Service Bulletin

Bulletin No.: 17-NA-357

Subject: Noise or Malfunction of Trim Door on Broken Quarter Upper Trim Panel, Possible Convertible Top Inoperative

6750826

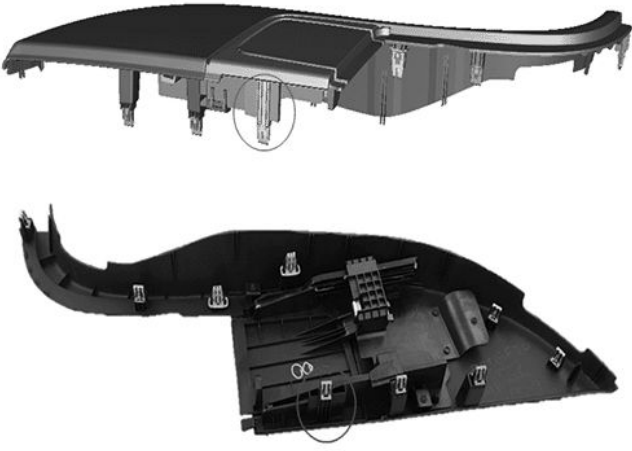
Example	Quarter Upper Trim Panel flip door in correct position on tracks with the top down:

Important: DO NOT apply any downward force on this door while the folding top is down.

6750827

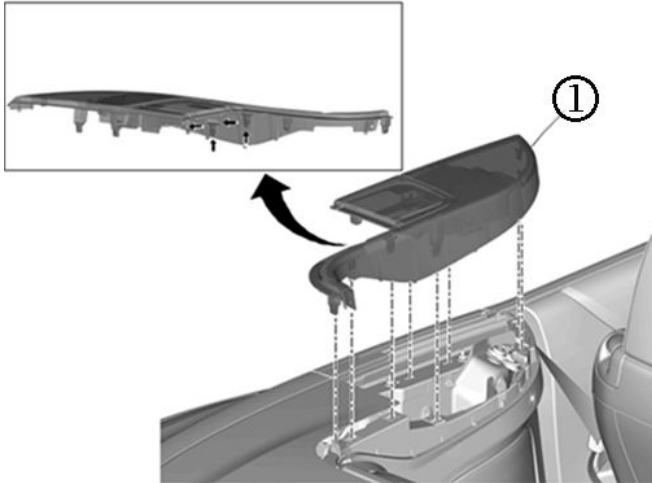
This is an example of the door off the track and vulnerable to damage if folding top is commanded to close.

4889569

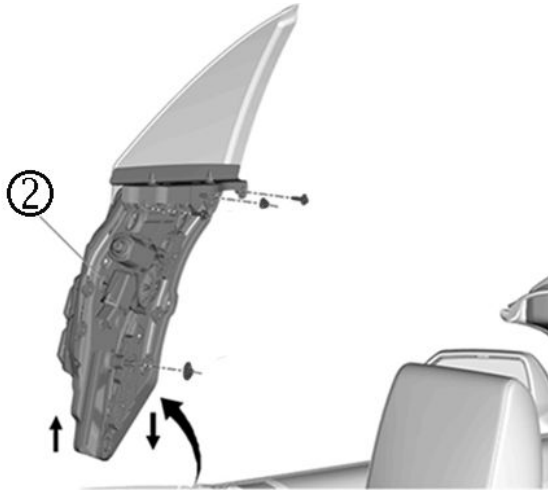
Note: For vehicles built prior to February 14, 2017, it will also be necessary to replace the window regulator in addition to the quarter upper trim panel to accommodate the added 3rd clip design.

Important: Under no circumstances should the 3rd clip be removed from the quarter upper trim panel.

- **For vehicles-built February 14, 2017 and after**, replace the quarter upper trim panel (1) AND the rear side rail link assembly at the same time. Refer to *Quarter Upper Trim Panel Replacement* and *Folding Top Rear Side Rail Link Trim Cover Replacement* in SI.

- For vehicles built prior to February 14, 2017, replace the quarter upper trim panel AND the quarter window regulator (2). Refer to *Quarter Window Regulator Replacement* in SI.
